## **BOH COMMERCIAL SUBDIVISION**

The purpose of this application is to create a one-lot subdivision from three metes and bounds parcels.

APPLICATION NUMBER 12 DATE April 7, 2005

# BOH COMMERCIAL SUBDIVISION

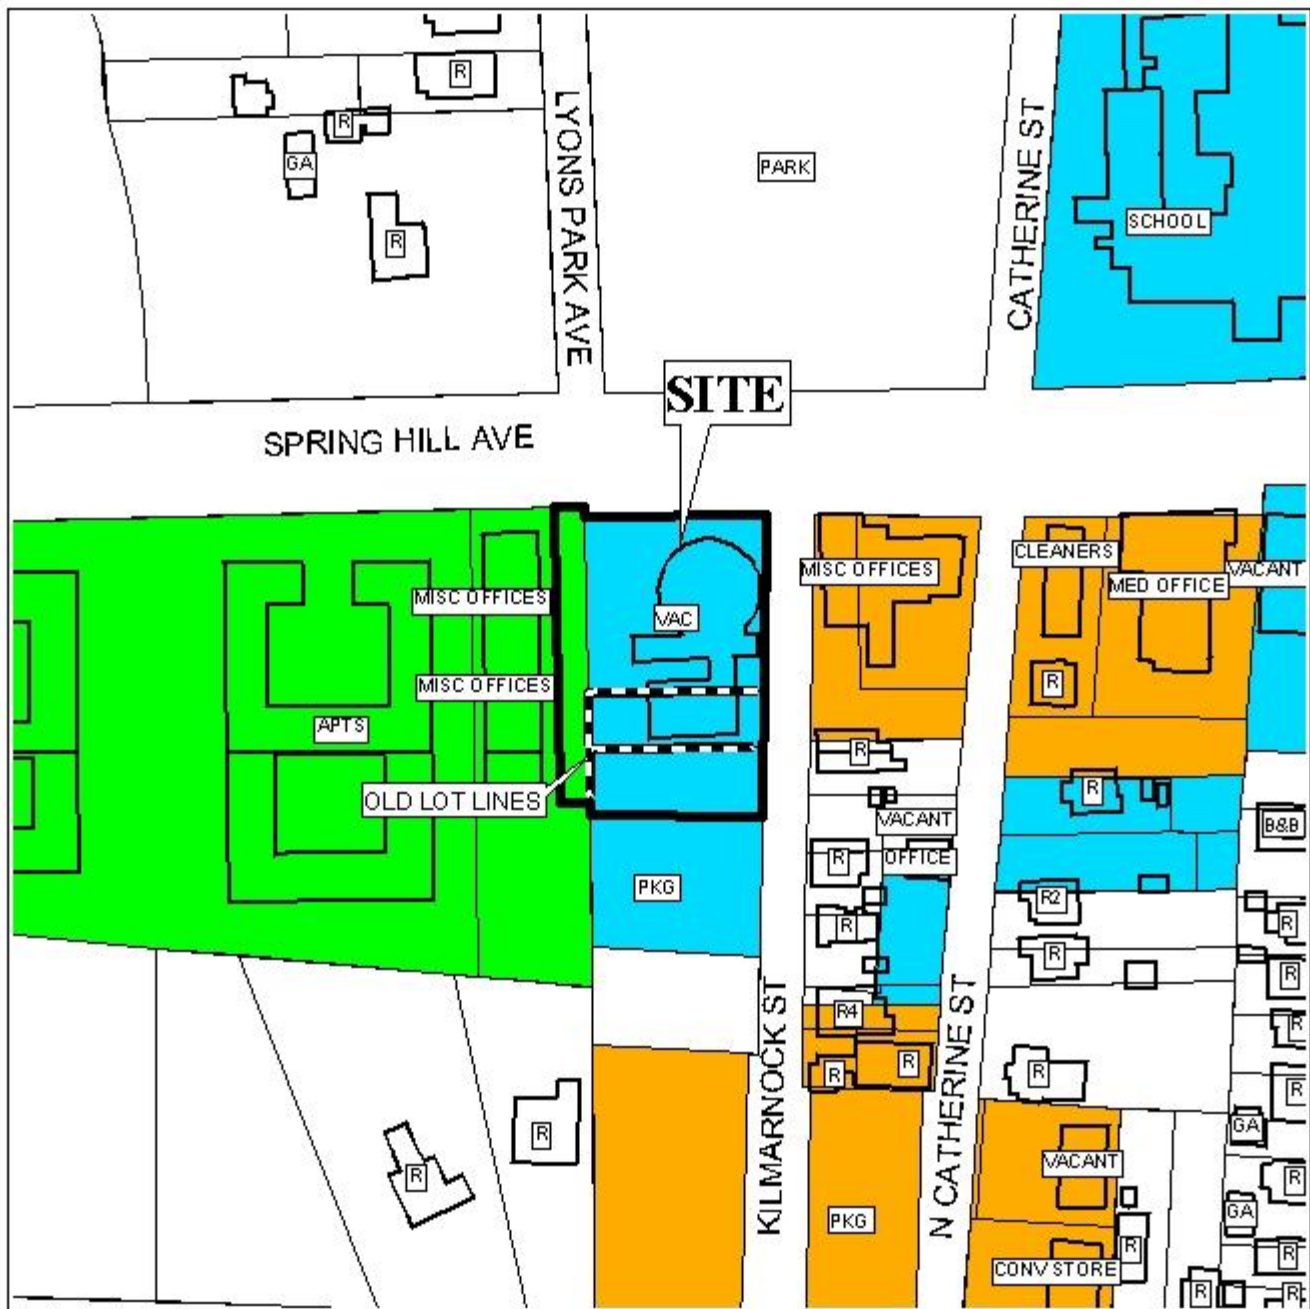
As illustrated on the Vicinity Map, the site is split-zoned, with the majority of the site zoned B-1, and a "sliver" along the West property line is zoned R-3; thus the lot should be rezoned to a single zoning classification prior to the recording of the final plat.
